UNITED STATES PATENT AND TRADEMARK OFFICE

APPLICATION NO.	FILING DATE	FIRST NAMED INVENTOR	ATTORNEY DOCKET NO.	CONFIRMATION NO.
10/543,026	07/21/2005	Emmanuel Legrand	047578/294907	9198

Office Action Summary	Application No. 10/543,026	Applicant(s) LEGRAND, EMMANUEL	
	Examiner GHASSEM ALIE	Art Unit 3724

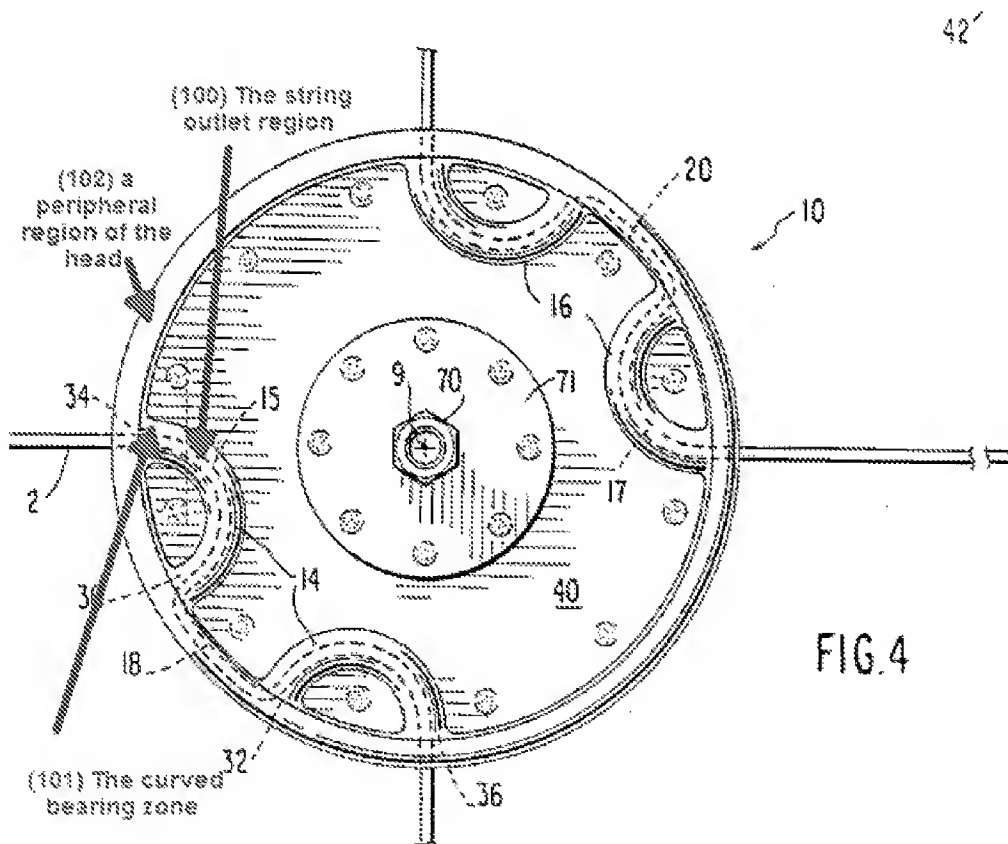
8. Claims 1-5 and 9-14 are rejected under 35 U.S.C. 102(b) as being anticipated by Rouse (4,756,146). Regarding claim 1, Rouse teaches a cutting head 10 including a passageway 14 for a cutting string 2 and at least one curved bearing zone 101 extending

between a string outlet region 100 of the passageway and a peripheral region 102 of the head.

It should be noted that the string outlet region could be defined by the mid-section of the passage, and the curved bearing region could be considered as the region between the string outlet region to the periphery region of the head as show in Fig. 1 below. Rouse also teaches that a surface of the curved bearing zone presents a recessed profile 46 which is substantially complementary to a part of cross-section of the cutting string 2, in order to guide the cutting string in the recess when the string flexes in a direction opposite to the rotation of the head to rest against the curved bearing zone.

Applicant's argument that Rouse does not teach any bearing zones or any other features extending between the string outlet regions and the periphery of the head is not persuasive. As stated above, Rouse teaches at least one curved bearing zone 101 extending between a string outlet region 100 of the passageway and a peripheral region 102 of the head. It should be noted that the string outlet region could be defined by the mid-section of the passage, and the curved bearing region could be considered as the region between the string outlet region to the periphery region of the head as show in Fig. 1 above.
